Re: Cargill Fertilizer - Riverview Plant Expansion DEP File No. 0570008-036-AC; PSD-FL-315

This letter serves as a response to the letter from the Department dated April 11, 2001 in reference to the Riverview Plant Expansion project. The following is additional information requested, numbered as appeared in your letter:

## Response No. 1

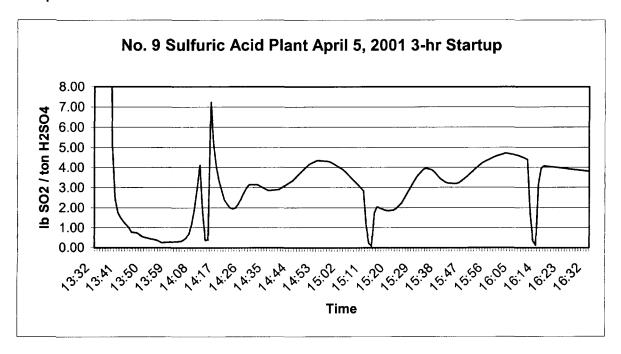
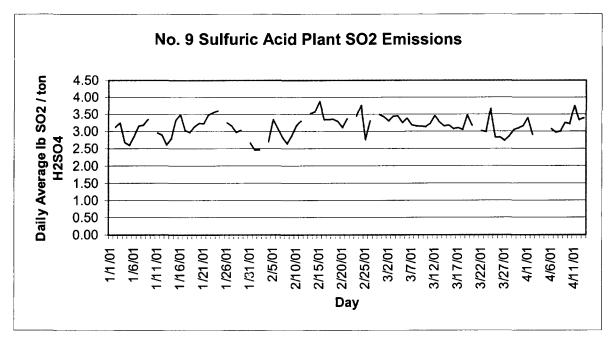
- There is also a concern about achieving this lower emission rate during plant startups. Currently, even the No. 9 plant is not able to achieve 3.5 lb SO<sub>2</sub>/ton H<sub>2</sub>SO<sub>4</sub> within 3 hours of each startup (see attached CEM data). Imposition of the shorter averaging time will result in additional plant start ups in order to comply with the established "Memorandum of Understanding Regarding Best Operational Start-up Practices for Sulfuric Acid Plants" as contained the facility Title V operating permit. Under these established requirements, the unit is required to be within the permitted emission rate within 3-hours of initiation of a start up. Our extensive experience has shown that compliance with this condition requires very strict adherence to operating guidelines in order to attain the existing 4 lb SO<sub>2</sub>/ton H<sub>2</sub>SO<sub>4</sub> limit within 3 hours of startup. Reduction of the limit on a 3-hour basis will inevitably have two consequences. Both resulting in additional emissions. First, the unit will be required to burn additional fossil fuel in order to increase catalyst temperatures prior to initiation of a cold start up. Emissions from the fossil fuel combustion will not provide any production value. Second, the likelihood of a start-up not achieving the established emission limit within the 3-hour time limit will increase. In accordance with the Best Practices, this will require
